# Access Compliance Report

## Public Rights-of-Way

### (Curb Ramps)

Intersection ID: 3907	Main Street: ALNWICK_CT	Cross Street: COPPERPLATE_RD	Location:	N
ADA ID: 311F2155B2B4	Ramp Type: Perp	Initial Pass/Fail: Fail	Overall Compliance: No	Severity Score: 1.25
Codes/Mitigation Info/Possible Solution		Field Measurements/Component Compliance

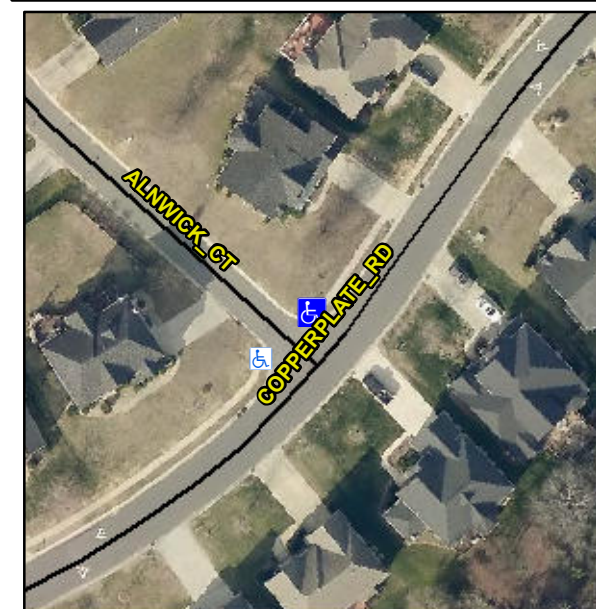
**Not Found, R304.5.3**

Compliance	Description	Data	Compliance	Description	Data
N/A	Ramp Length (in)	47.0	Yes	Ramp Slope (%)	7.0
Yes	Ramp Width (in)	48.0	No	Ramp XSlope (%)	3.3
N/A	Flare Type LT	N/A	N/A	Flare Type RT	N/A
N/A	Flare Slope LT (%)	N/A	N/A	Flare Slope RT (%)	N/A
N/A	Flare Traversable LT?	N/A	N/A	Flare Traversable RT?	N/A
N/A	Landing Length (in)	N/A	N/A	DWS Provided?	N/A
N/A	Landing Width (in)	N/A	N/A	DWS Contrast?	N/A
N/A	Landing Slope (%)	N/A	N/A	DWS Length (in)	N/A
N/A	Landing X Slope (%)	N/A	N/A	DWS Full Width?	N/A
N/A	Landing Curb? (Y/N)	N/A	N/A	DWS Offset (in)	N/A
N/A	Shared Landing?	N/A			
N/A	Gutter Ponding?	N/A	N/A	Gutter Slope (%)	N/A
N/A	Gutter Lip Ht (in)	N/A	N/A	Gutter X Slope (%)	N/A
N/A	Painted X Walk1?	No	N/A	Painted X Walk2?	N/A
	X Walk 1 Direction	To SW		X Walk 2 Direction	N/A
N/A	X Walk 1 Width (in)	N/A	N/A	X Walk 2 Width (in)	N/A
	X Walk 1 Slope (%)	0.4		X Walk 2 Slope (%)	N/A
	X Walk 1 X Slope (%)	1.7		X Walk 2 X Slope (%)	N/A

**Remove & Replace Entire Ramp.**
